TOWN OF PALM BEACH
Planning, Zoning & Building Department
360 South County Road
Palm Beach, FL 33480
(561) 838-5431 • www.townofpalmbeach.com

PLANNING, ZONING, & BUILDING DEPARTMENT
PZ&B Staff Combination Memorandum: Architectural Commission and Town Council

SUBJECT: ARC-23-109 (ZON-23-084) 600 TARPON WAY (COMBO)

MEETING: NOVEMBER 20, 2023 ARCOM

Building Height Plane Encroachment Diagram

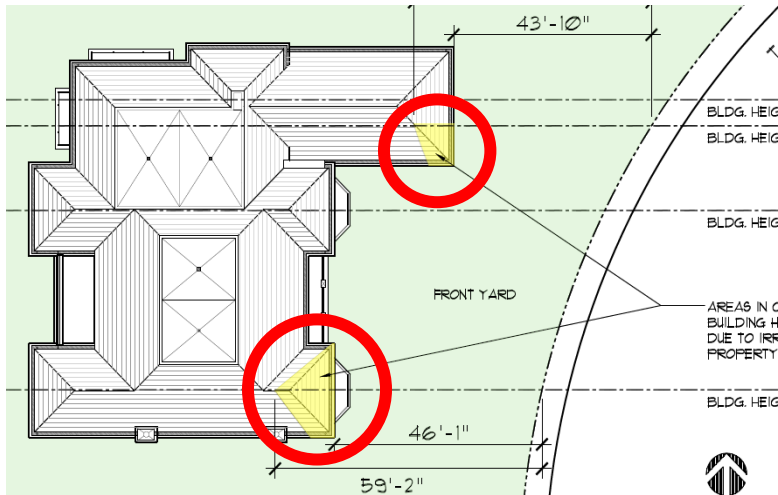
As the diagram to the left illustrates, **Variances 1 and 2** occur where two portions of the building's roof intersect with the building height plane.

The building height plane is a height limiting angle that extends at an incline from the intersection of the front property line and the property's code prescribed zero datum (7' NAVD) at a rate of two feet (2') of front setback for every one foot (1') of building height.

Code Section	Required	Proposed	Variance
Variance 1: Sec. 134-843(7):	Building Height Plane of 52'-8"	Building Height Plane of 43'-10"	8'-10" GARAGE WING ROOF
Variance 2: Sec. 134-843(7):	Building Height Plane of 59'-2"	Building Height Plane of 46'-1"	13'-1" RESIDENCE SOUTH ROOF

Mechanical Equipment Enclosure Front Yard Encroachment Diagram

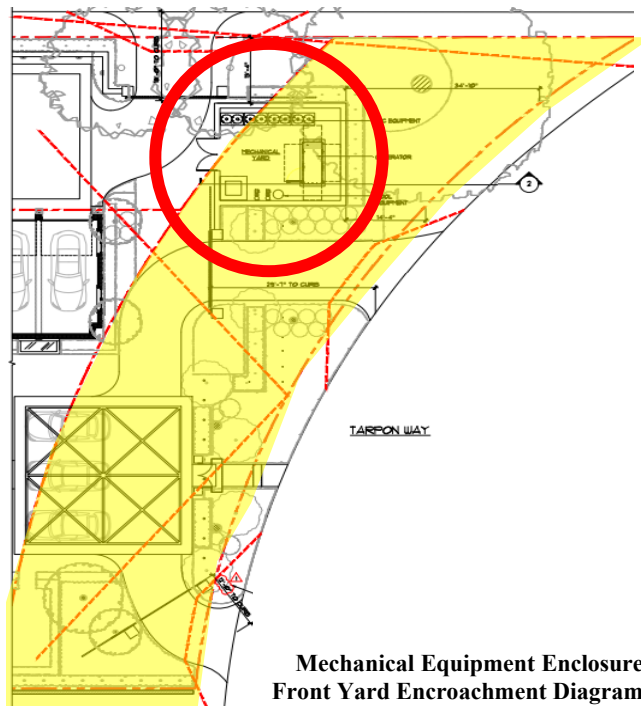
Variances are also required for the proposed location of the property's equipment yard. The equipment yard is located within the front yard's 35' setback, indicated in yellow on the graphic to the right. The equipment yard contains the property's AC condensing units (**Variance 3**), a 60kW generator (**Variance 4**), and the pool equipment (**Variance 5**) – all of which are prohibited within the front yard setback.

Additionally, when pool equipment is located within a required yard area, its location cannot exceed a separation distance greater than 25 linear feet from the pool water's edge. As the pool is located at the rear of the property at a distance greater than 25' from the equipment, an additional variance for the pool equipment is required (**Variance 6**).

Wall Height Variance Diagram

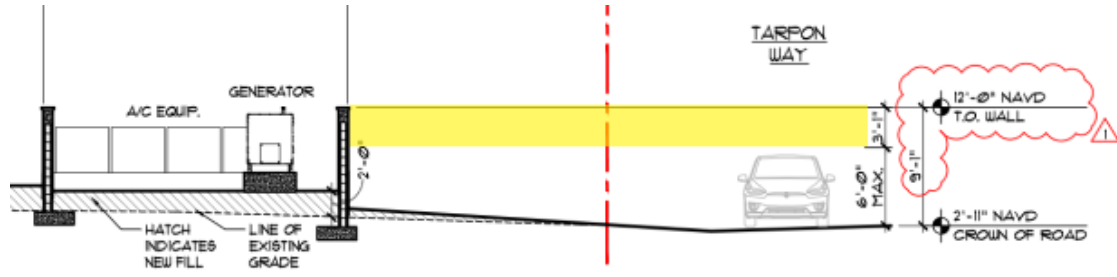
Lastly, all equipment within required yard areas shall be screened from adjoining properties with a masonry wall as high as the equipment. The applicant is proposing masonry screening walls to the top of the equipment (9'-1"), but walls located within the Front Yard Setback are limited to 6'-0" in height as measured from the adjacent crown of road. Therefore, a variance to increase allowable wall height by 3'-1" is required (**Variance 7**). The variance diagram below illustrates the 3'-1" variance amount in yellow as measured from the crown of road.

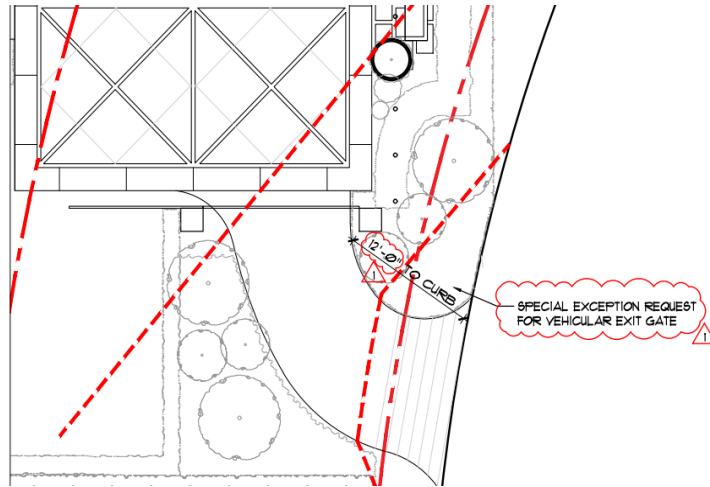
A **Special Exception** is also requested from the Town Council to permit a new vehicular gate at the south end of the front circular driveway. The proposed gate has a 12' setback from the edge of pavement in lieu of the 18' setback required for vehicular queuing.

Typically, a request to reduce a vehicular gate setback requires a variance, but as Tarpon Way is a dead-end street terminating at Tarpon Island, a Special Exception is required.

Code Section	Required	Proposed	Exception
Special Exception Sec. 134-1668 :	18' Minimum Vehicular Gate Setback	12' Vehicular Gate Setback	6'-0" Reduction
